UN#10-157

Subject: UniStar Nuclear Energy, NRC Docket No. 52-016  
Response to Request for Additional Information for the  
Calvert Cliffs Nuclear Power Plant, Unit 3,  
RAI 240, Questions 02.05.04-21, 22, and 23, Stability of Subsurface Materials  
and Foundations

**Response to NRC Request for Additional Information RAI No. 240,  
Questions 02.05.04-21, 22, and 23, Stability of Subsurface Materials and Foundations,**

**Figure 3.7-2—{CCNPP Unit 3 GMRS (Horizontal) and CCNPP Unit 3 Site SSE Spectrum, 5% damping}**

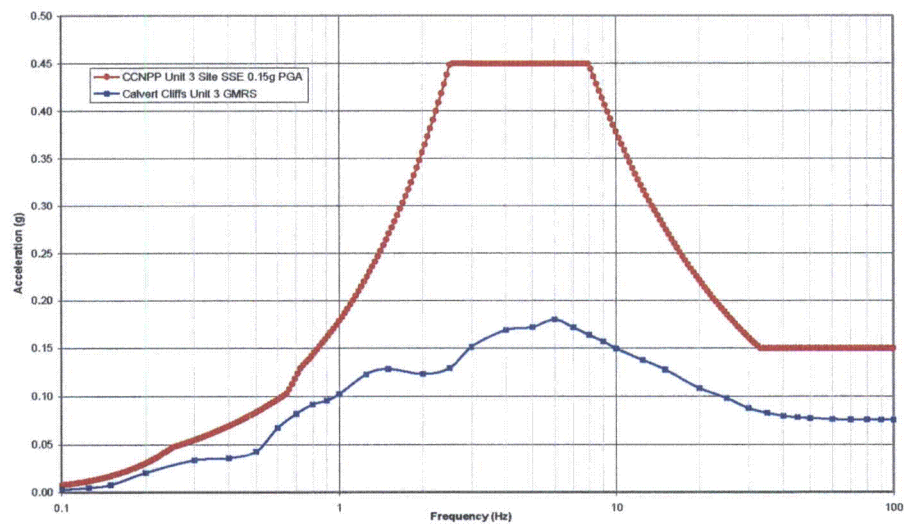
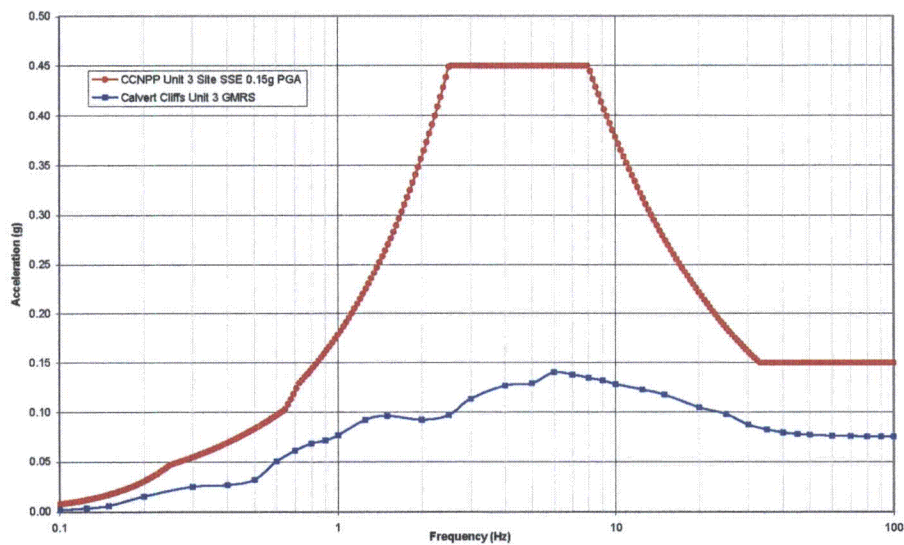
FSAR Section 2.5.4.7 states that the SSE spectra "would be expected to be modified as appropriate to develop ground motion for design considerations." Please justify why the GMRS would need modification during design and clarify when this design will occur. Please provide the results of such modifications when performed and appropriately update the FSAR. The requested information must be in sufficient detail for the evaluation of the suitability of the proposed site and adequacy of the design bases in accordance with 10 CFR 100.23.

The Site SSE ground motion for CCNPP Unit 3 is the envelope of the U.S. EPR FSAR European Utility Requirements (EUR) Soft Soil spectrum anchored at 0.15 g and the horizontal RG 1.60 spectrum anchored at 0.1 g, therefore satisfying the requirements of Appendix S of 10 CFR Part 50. The Site SSE ground motion, which is specified for both horizontal and vertical directions, is presented FSAR Section 3.7.1.1.1. FSAR Section 3.7.1.1.1 and Section 2.5.4.7 were revised by UniStar in letter UN#09-519<sup>1</sup>. The revised Section 2.5.4.7 and Figures 3.7-1, 2 and 3 are provided below and show the relationship of the Site SSE to the GMRS.

FIGURE 2.5-401 –

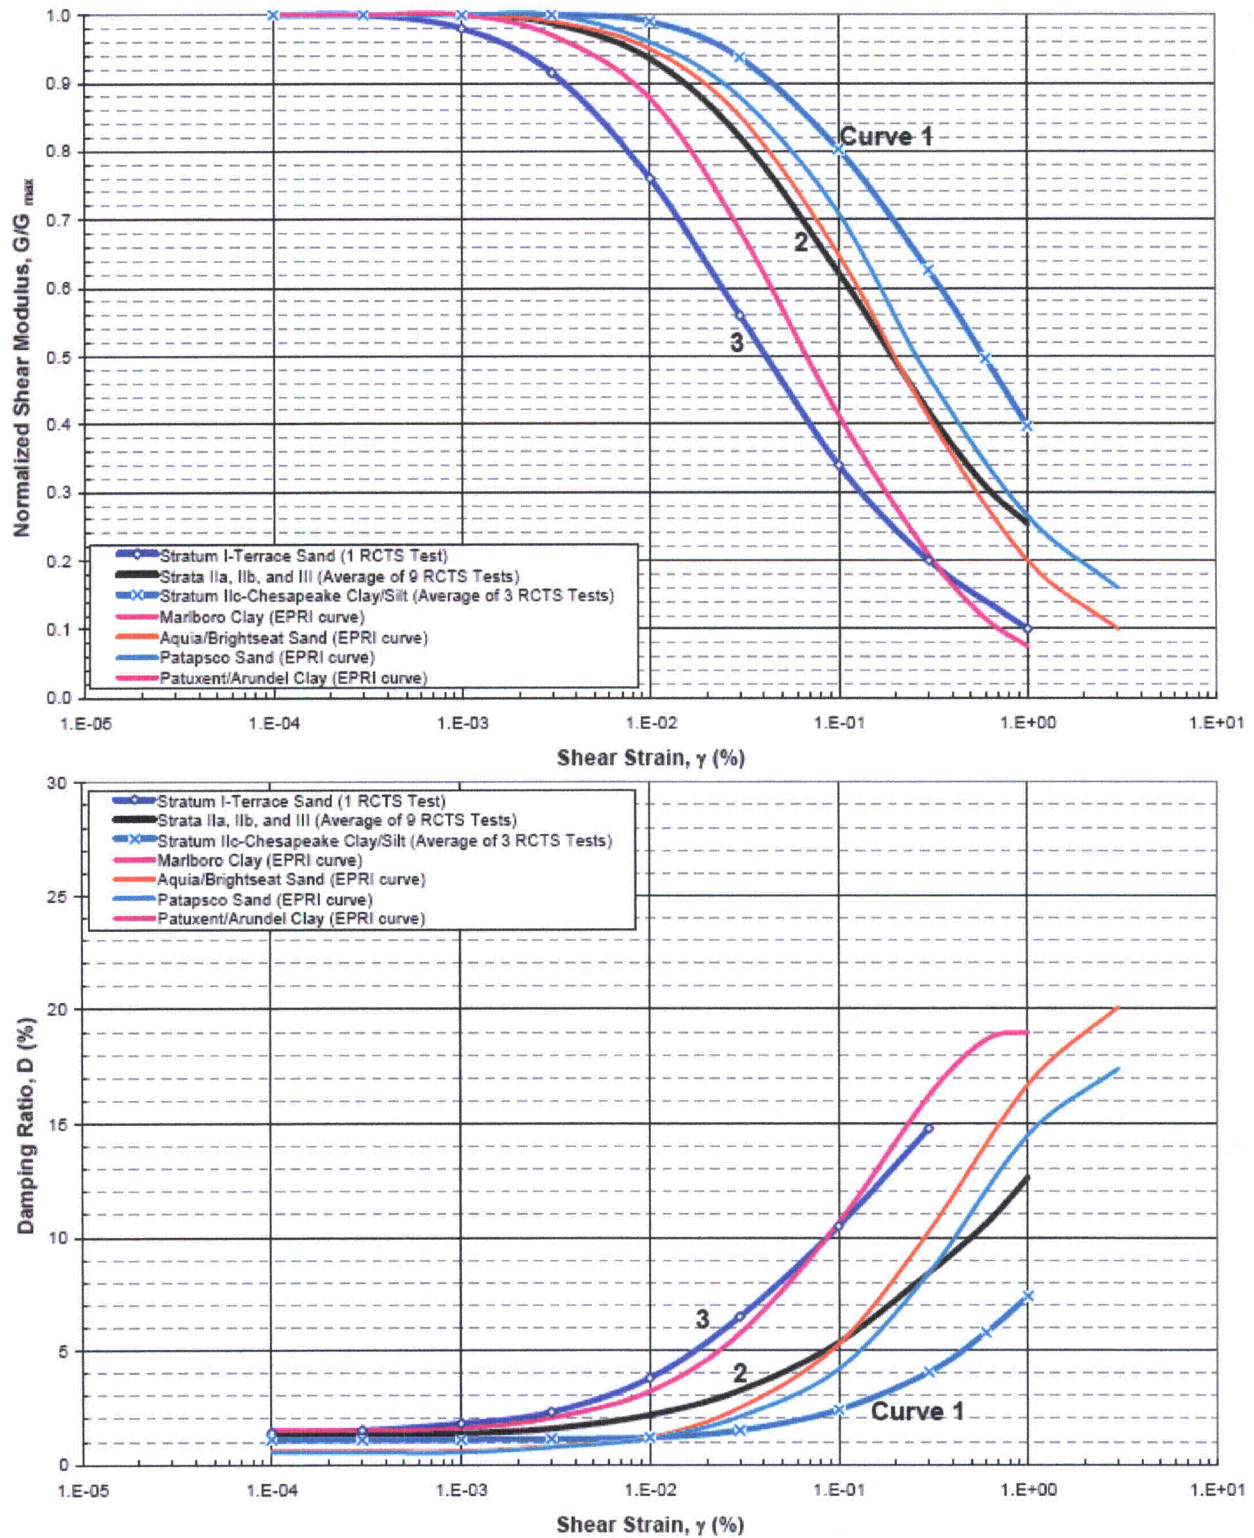
FSAR Subsection 2.5.4.2.5.9 states that for soils beyond 1000 ft in depth, EPRI curves were extrapolated from the EPRI sand curves that have a range of 1000 ft in order to characterize deeper soils. Provide a basis for the extrapolation method, a figure showing examples of the shear modulus and damping curves for depths below 1000 ft, and a description of the impact of variation of the extrapolated curves on the site response analysis. Please appropriately update the FSAR with the requested information. This request is in accordance with 10 CFR 100.23.

To assess their utilization, EPRI curves initially adopted for these soils were compared with the set of curves derived from the RCTS results for the upper soils, as shown in FSAR Figure 2.5-401. The results indicate that:

- Marlboro Clay and Patuxent/Arundel Clay Curves: the EPRI curves are identical and fall nearly half-way between the RCTS-based curves for the Stratum I Sand (Curve 3) and Strata II and III soils (Curve 2) in their G/Gmax relationship and closer to Curve 3 in their damping relationship. Based on the available RCTS results, it is inconceivable for these soils at such great depths (and expected high strength) to behave as "softly" as Stratum I Sand (Curve 3) which is at relatively shallow depths and primarily non-plastic. Therefore, as a minimum, the Marlboro and Patuxent/Arundel clays are expected to behave closer to that represented by Curve 2. On this basis, Curve 2 is a reasonable representation for these soils and is used for the dynamic characterization of Marlboro Clay and Patuxent/Arundel Clay.

- Aquia/Brightseat Sand and Patapsco Sand: the EPRI curves are nearly identical and follow Curve 2 closely in their G/Gmax and damping relationship. Based on the RCTS results, and given their depths, these soils are expected to behave somewhere in the region represented by Curves 1 and 2, and possibly closer to Curve 1. Given that a number of the RCTS tests on sandy soils banded closely and were represented by Curve 2, the deeper sandy soils of the Aquia/Brightseat and Patapsco are expected to produce relationships that are mimicked by Curve 2, as a minimum. On this basis, Curve 2 is a reasonable representation for these soils and is used for the dynamic characterization of Aquia/Brightseat Sand and Patapsco Sand.
